SUBJECT: ISSUANCE OF AMENDMENT NO. 61 TO FACILITY OPERATING LICENSE NPF-10  
AND AMENDMENT NO. 50 TO FACILITY OPERATING LICENSE NPF-15  
SAN ONOFRE NUCLEAR GENERATING STATION, UNITS 2 AND 3 (TACS 65827/  
65828)

These amendments define as limiting conditions for operation the volumes and concentrations of borated water to be maintained in the refueling water storage tank and the minimum boron concentration for refueling.

These amendments were requested by your letter of July 17, 1987 and cover Proposed Change Number PCN-235.

Amendment No. 61  
License No. NPF-10

**Figure 3.1-1**  
**MINIMUM STORED BORIC ACID VOLUME**  
**AS A FUNCTION OF CONCENTRATION**  
**(Gallons)**

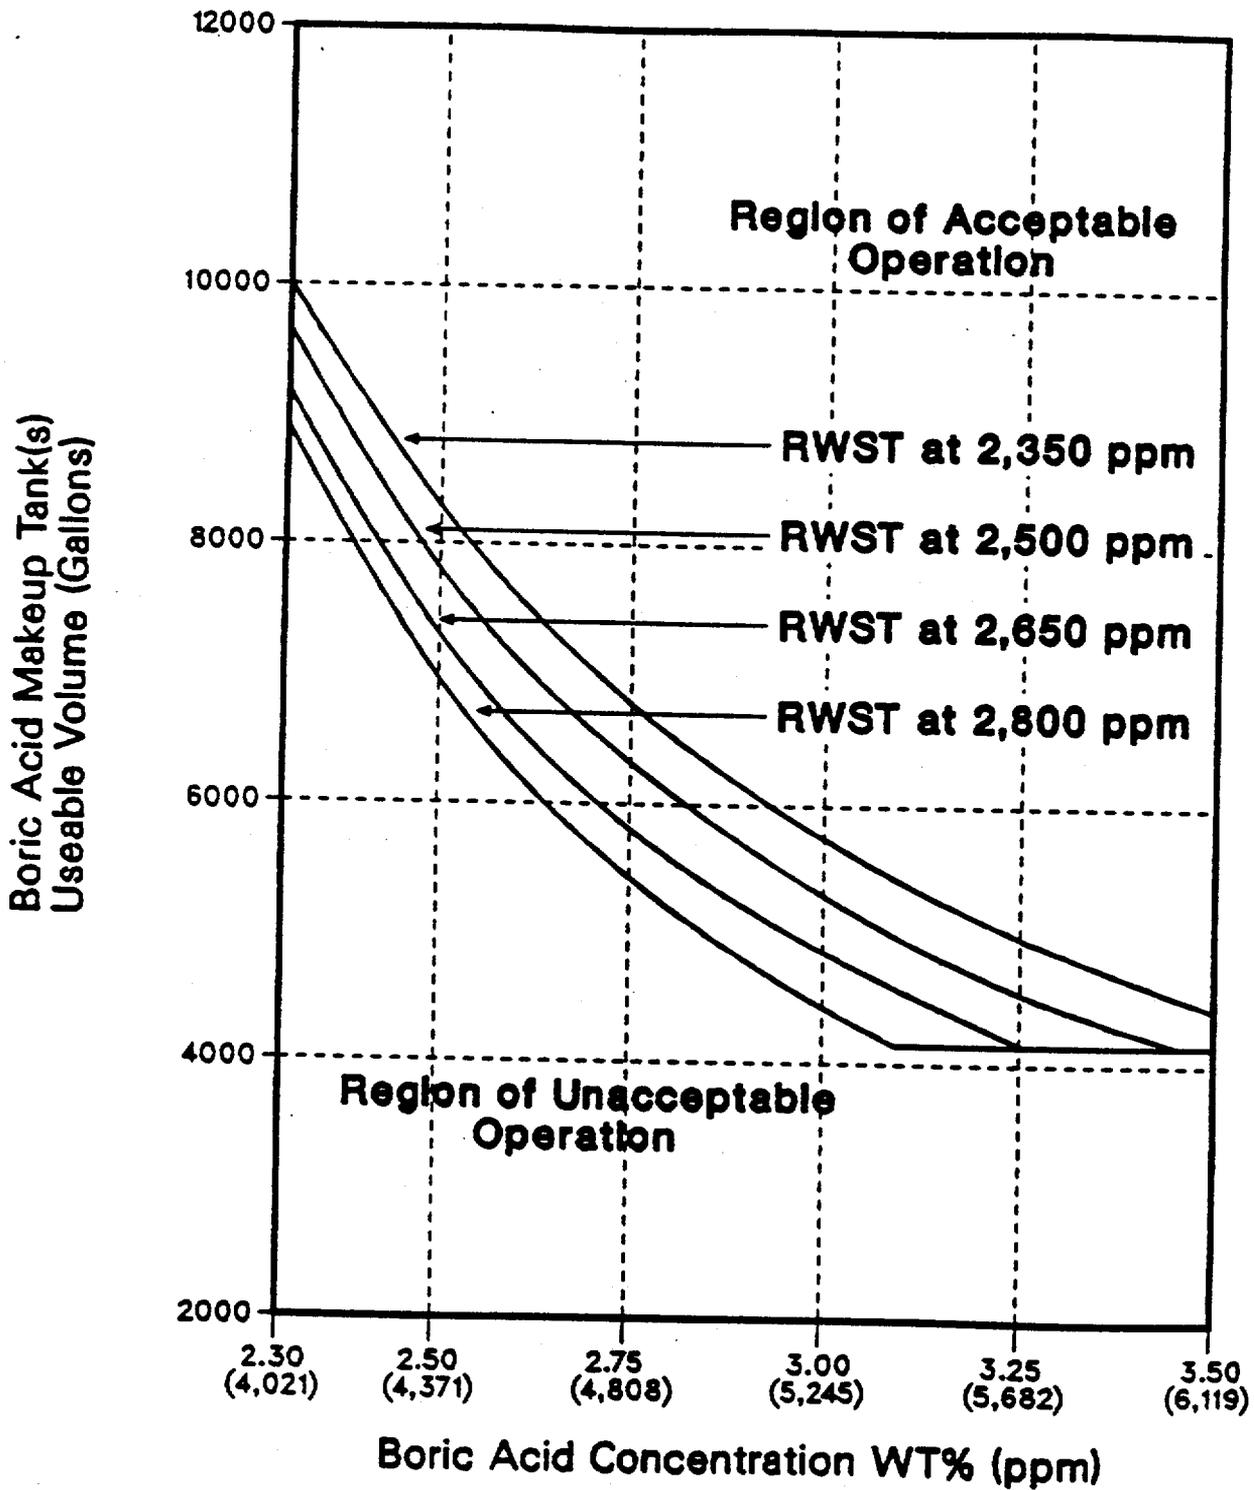
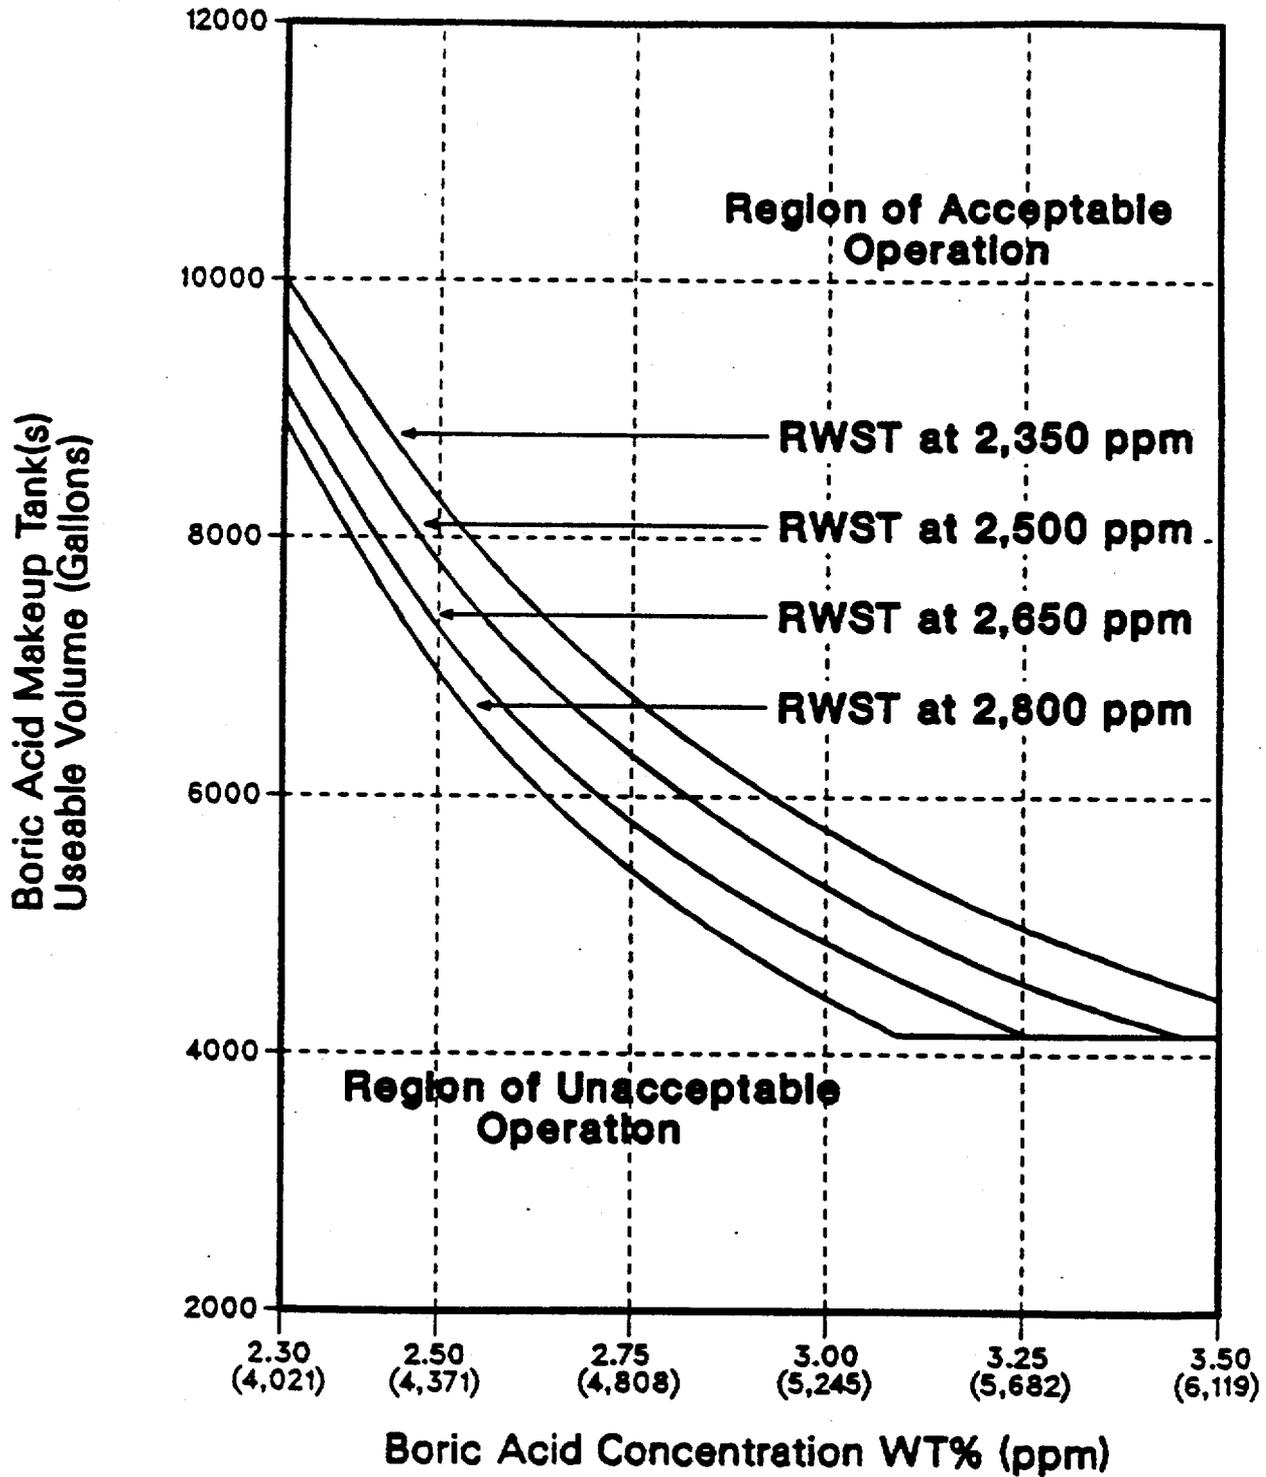
3. Revision of Figure 3.1-1, which specifies the volume and boron concentration to be maintained in the BAMT during operation to correspond to the increased RWST concentration range. The new curves in Figure 3.1-1 were calculated in CEN-316(s) to correspond to the new RWST concentration range and assure that sufficient inventory is maintained in the BAMT to support a cooldown while maintaining 5.15% shutdown margin. This is higher than the required 3.0% k/k shutdown margin after xenon decay and a plant cooldown to 200°F from expected operating conditions, assuming unavailability of off site power and loss of the letdown line. The inventory and concentration of the RWST will be sufficient to support natural circulation cooldown. The inventory and concentration have been estimated using approved methods and can maintain a shutdown margin greater than that required for CE plants (Ref. 3); hence, they are acceptable.

4. Decrease the volume of the minimum required borated water in the BAMT when the plant is in cold shutdown (or refueling) from 5,150 to 4,150 gallons. This change is reflected in the BAMT Figure 3.1-1 discussed above and is a direct consequence of the increased boron concentration. The new minimum volume with its corresponding concentration can maintain a minimum of 3.0% shutdown margin after xenon decay during cooldown from 200°F to 140°F. The 4,150 gallons are required to make up for coolant contraction during cooldown. The volume specified is adequate to maintain the required shutdown margin for CE plants (Ref. 3), and it is acceptable.
